Service Bulletin

Bulletin No.: 23-NA-135

Subject: Information on Oil Level Control Changes and Compatibility on 2023-2024 9-Speed Transmissions

6396977

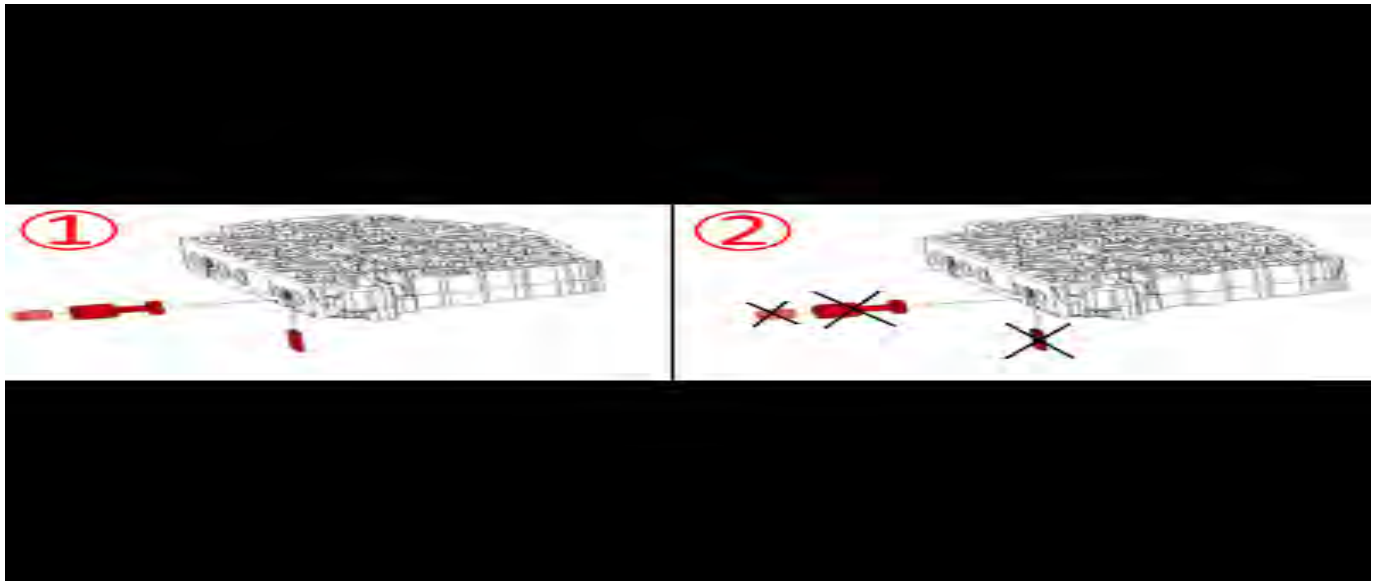
- 1) To only be used in model year 2022 and prior.
- 2) Can be used in any model year.

The previous a/trans fluid level control valve on the standpipe (item #21) had a small thermal door. The new style can be recognized by the larger thermal door on the standpipe. The larger thermal door is necessary for the removal of the OLC components.

6396979

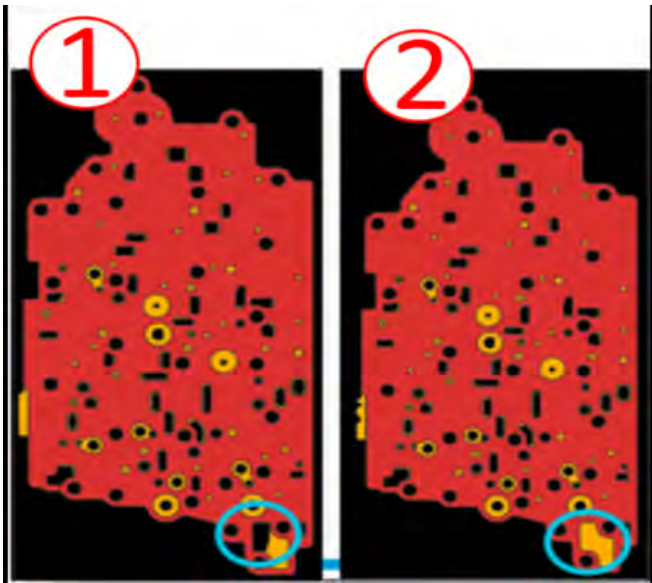
- 1) For use in model year 2023 and prior (w/OLC).
- 2) For use in model year 2024 and forward (w/o OLC).

The valve body will eliminate the a/trans fluid valve (item #437 and #436).

6397367

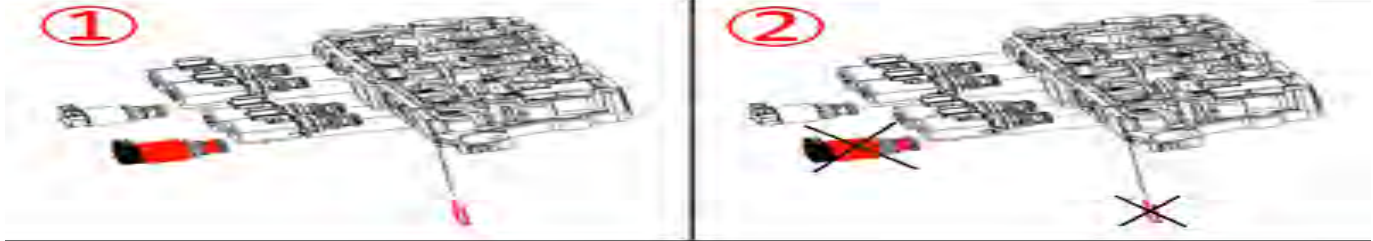
- 1) For use in model year 2023 and prior (w/OLC).
- 2) For use in model year 2024 and forward (w/o OLC).

The valve body to transmission case spacer plate is covering over the port (item #456).

6397498

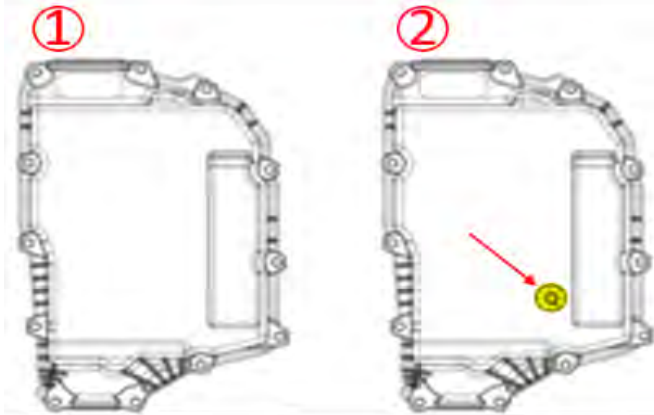
- 1) For use in model year 2023 and prior (w/OLC).
- 2) For use in model year 2024 and forward (w/o OLC).

The solenoid body will eliminate the a/trans fluid control solenoid (item #403).
